REPORT OF INSPECTION – FIXED WOOD BLEACHERS

Inspection Date:	Staunton High School	Inspected By:
Facility:	Old Gym	Bill & Courtland
Location:	801 N. Deneen Staunton, IL 62088	Bulte Company
Sent to:	Brian Dustman	Technicians

FIXED WOOD BLEACHER INSPECTION

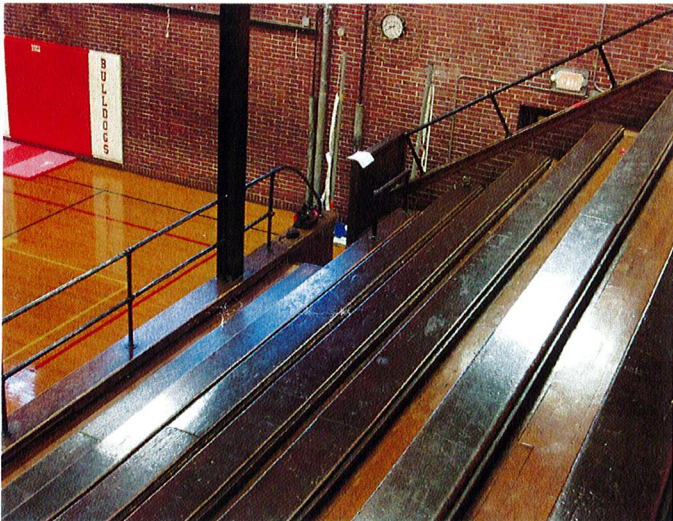
Open railing at the front walkway is a fall hazard. Narrow entry steps and no handrail.

Open railing at the upper walkway. Side rail is not 42" h and is open. Steps are too narrow.

Front edge of steps worn down and no tread tape—slip hazard.

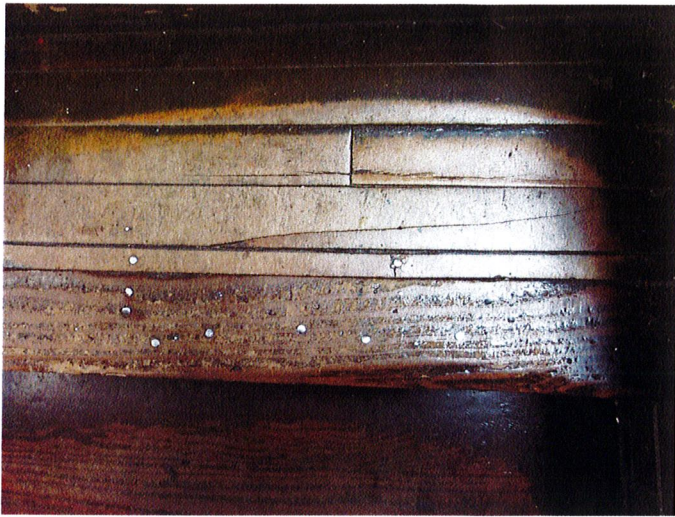
Front row/walkway drops - trip /fall hazard. Worn front edges of steps—slip hazard.

Stair tread needing replacement.

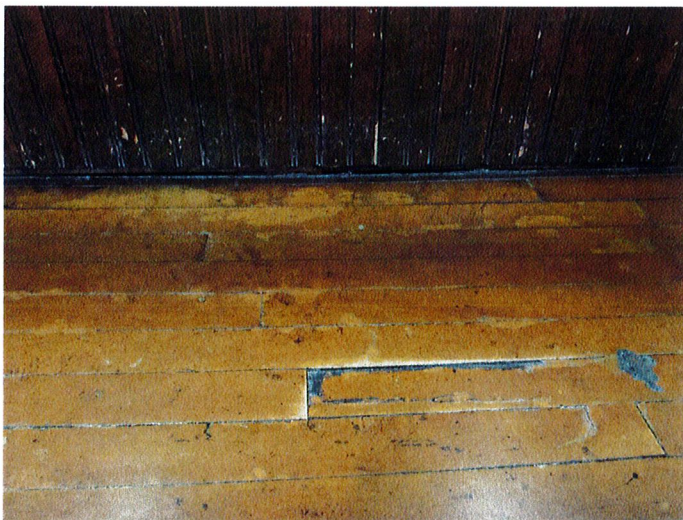
Open rails are a fall hazard .

Narrow stair landing and worn step nosing.

Floor patch is a trip hazard and is not stable.

Sinking floor board patch and poor understructure support.

Walkway floor understructure is failing and the floor is sagging.

Broken and exposed understructure with sharp edges on wood, bricks and concrete along the front walkway is a safety hazard.
